Rosebud Power Plant

2025 Annual Engineer's

Inspection Report

Prepared for Rosebud Operating Services, Inc.
by Allied Engineering Services, Inc.
2025 Report
Posted: January 15, 2026
Project #: 15-125

ROSEBUD SURVEY FIGURE
2025 ACTIVE LANDFILL (SLOPES)
ROSEBUD COUNTY, MT

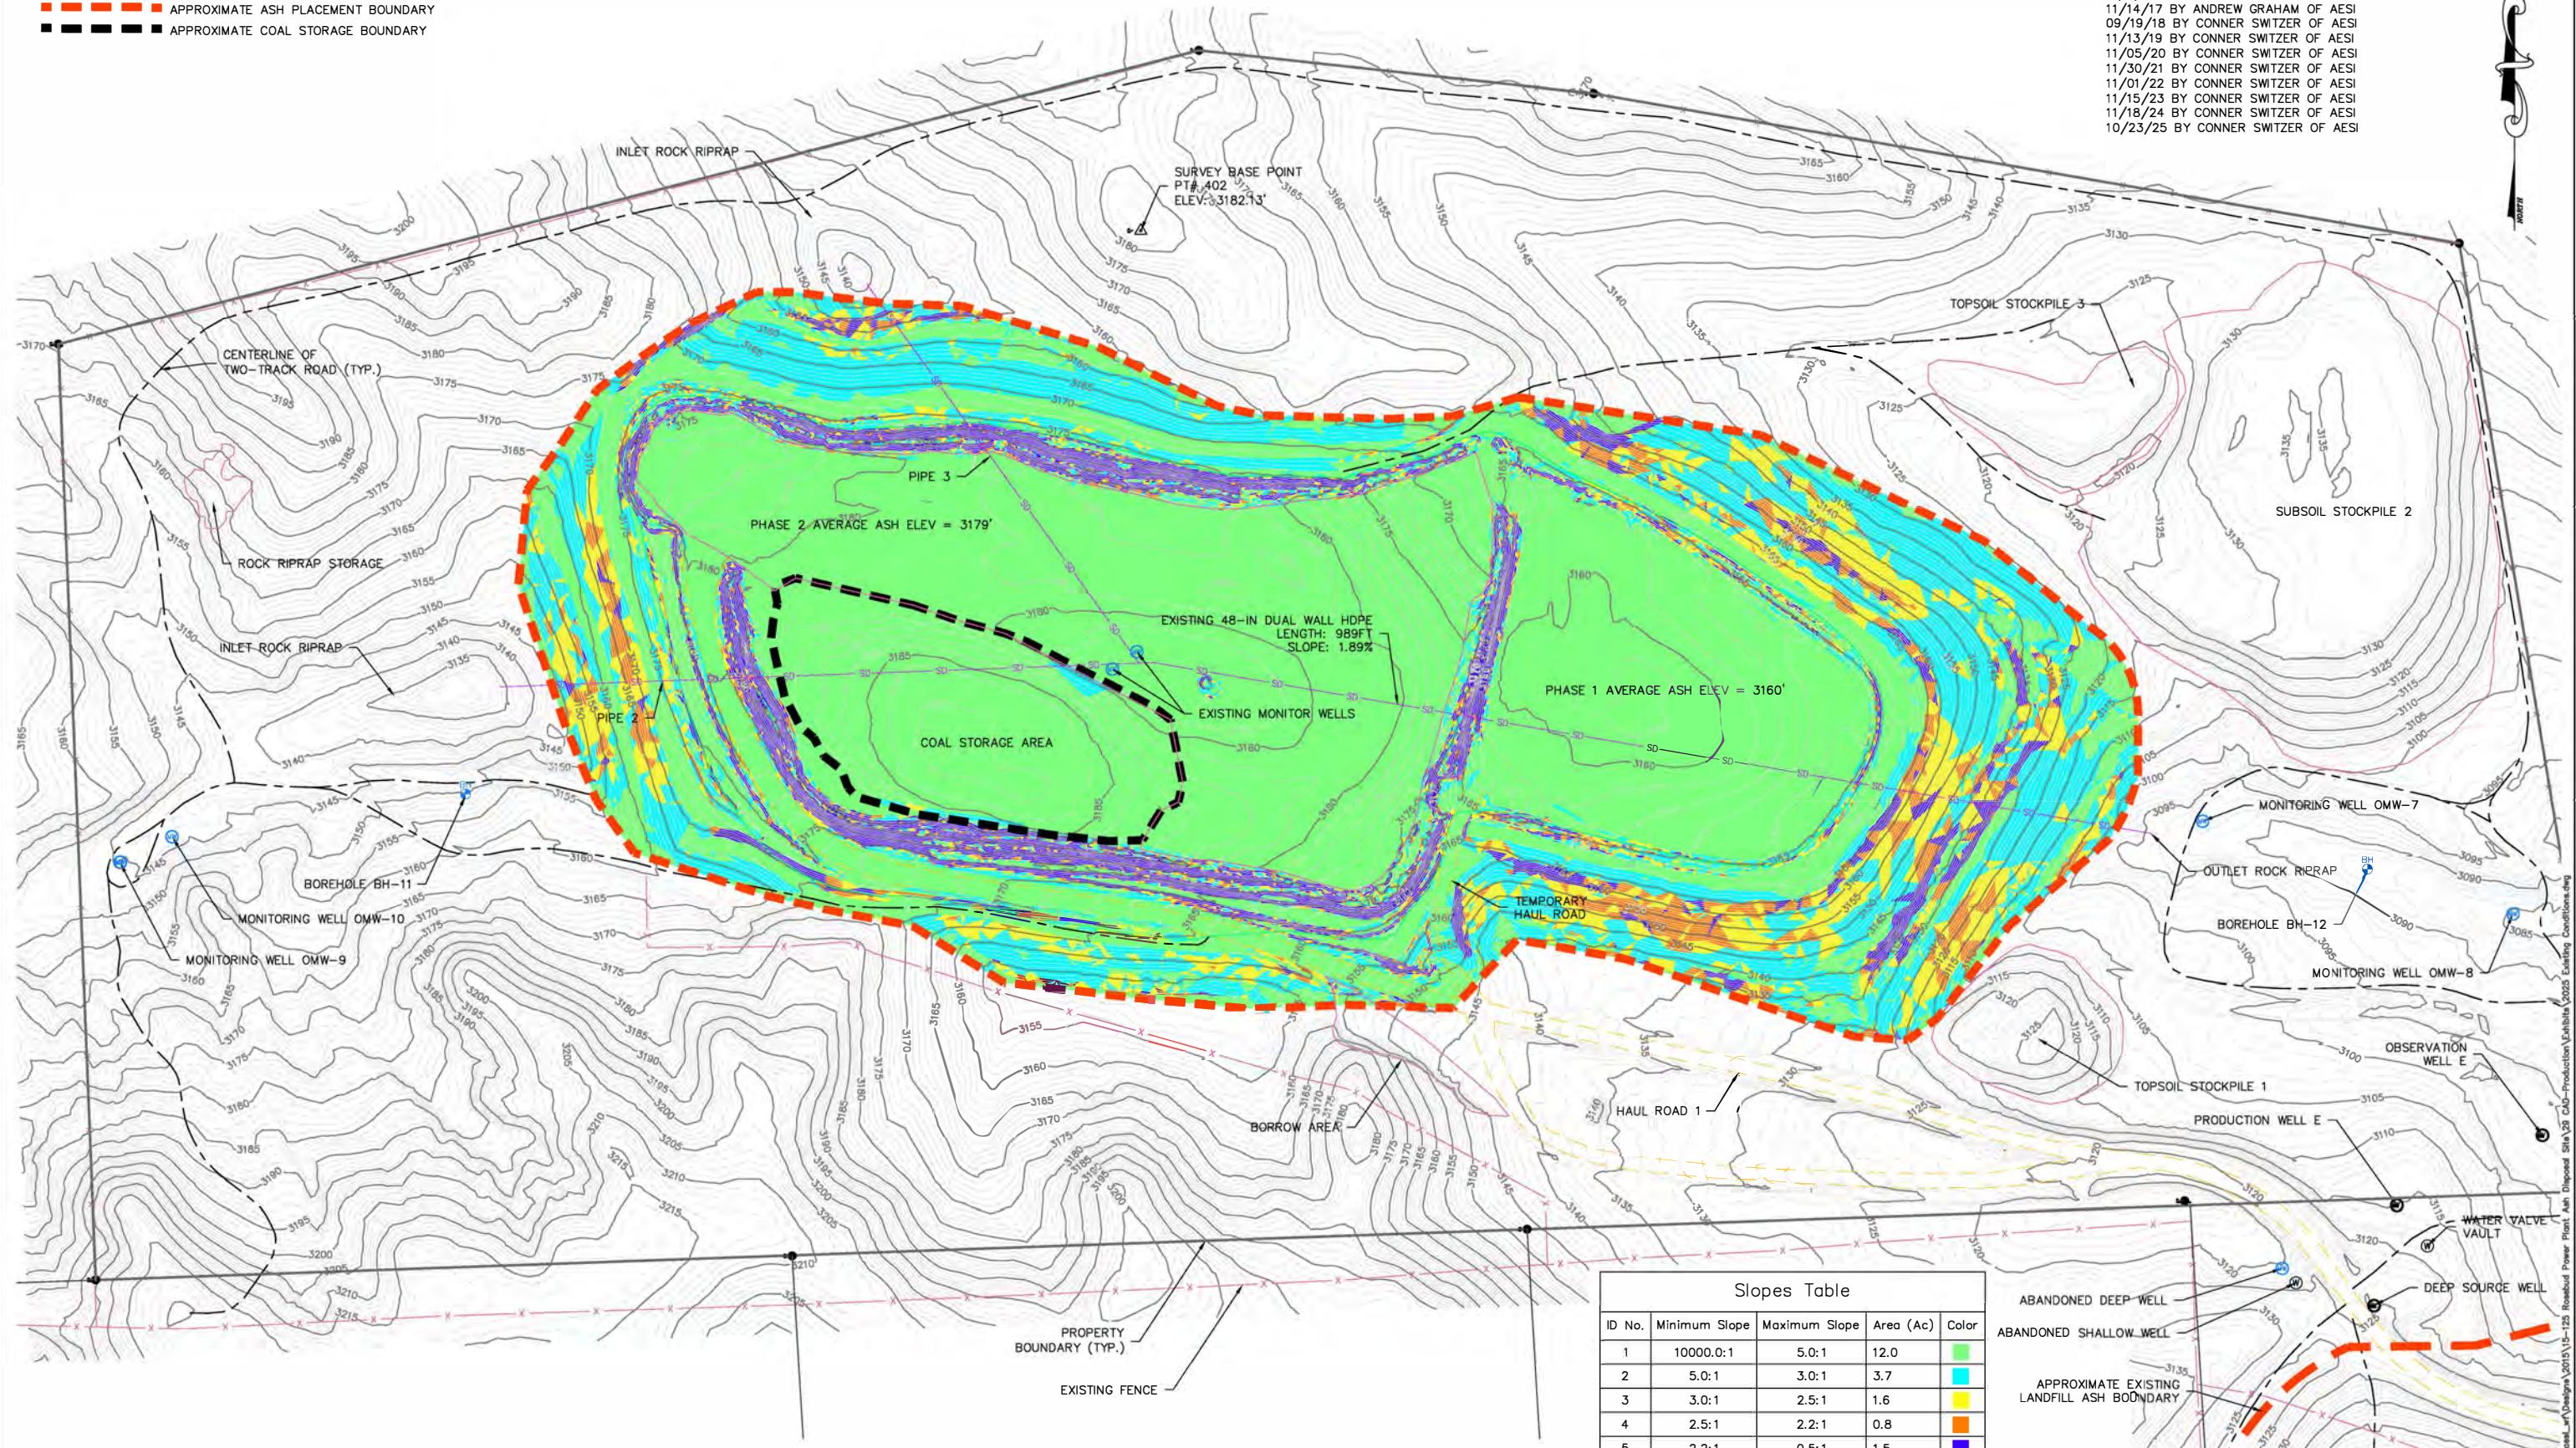
1. Continue grading outward facing slopes for berm construction (2025 and future) to ensure a 3H:1V side slope or flatter geometry. Any existing (2025 or earlier) or future finished slopes steeper than 3H:1V will require flattening from the bottom (i.e., additional fill placement) during final closure. See the attached Slope Figure for existing slopes. Note, areas that are orange and purple represent slopes steeper than 3H:1V.
